Spartan Fire, LLC

Technical Service Bulletin
TSB25-110-001

APPLIES TO: This service bulletin applies to certain model year 2010-2026 Gladiator and Metro Star, 2012-2014, 2017, 2019 Metro Star – RT, 2013-2018 Metro Star X, 2021-2026 FC-94, 2022-2026 KME Panther, and 2023-2025 KME Predator model emergency response chassis cabs built between February 2010 and July 2025.

CONDITION: Certain cab tilt crossbar tubes are cracking adjacent to the cab pivot mounts.

Figure 3.1

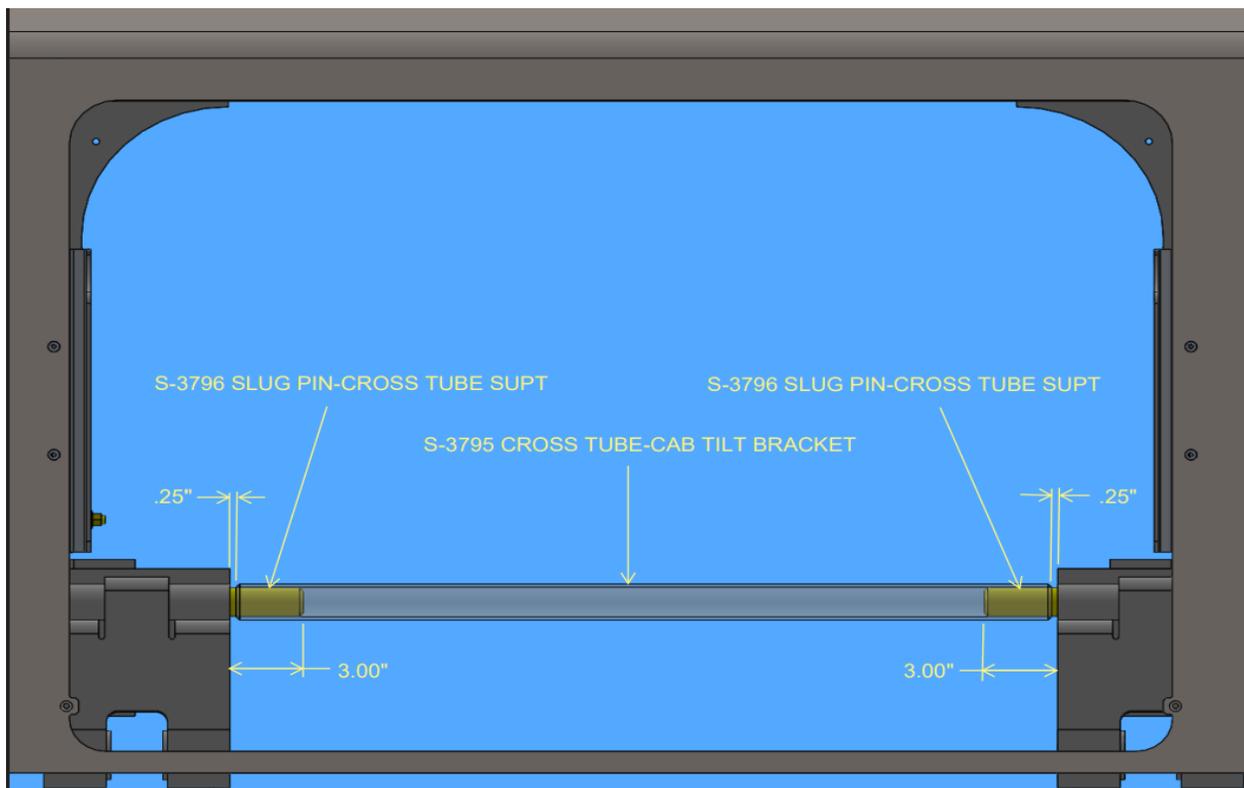
- 10) Position the new crossbar so that there is a 0.25 inch gap on each side between the crossbar and the pivot bracket tubes. This is to allow the weld that is to be applied to penetrate down into the slugs. *See Figure 3.1 below*

Table 5.1

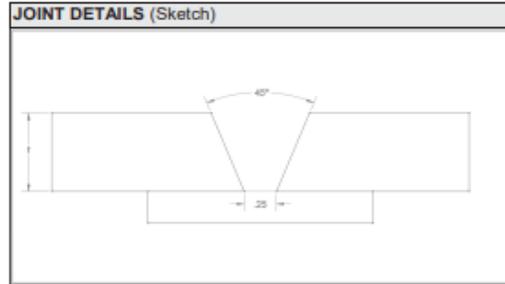
JOINT DETAILS	
Groove Type	Single V-Groove
Groove Angle	45°
Root Opening	0.25
Root Face	-
Backgouging	NA
Method	-
POSTWELD HEAT TREATMENT	
Temperature	-
Time at Temperature	-
Other	-

- * For any layer width >5/8" split layers are required.
 - ** 3/8" Max Root Pass Thickness
 - 1/4" Max Fill Pass Thickness
 - *** If base metal temperature is below 32°F, the base metal must be preheated to a min of 70°F
- 01-FRM043-001 2/11/2022 RH
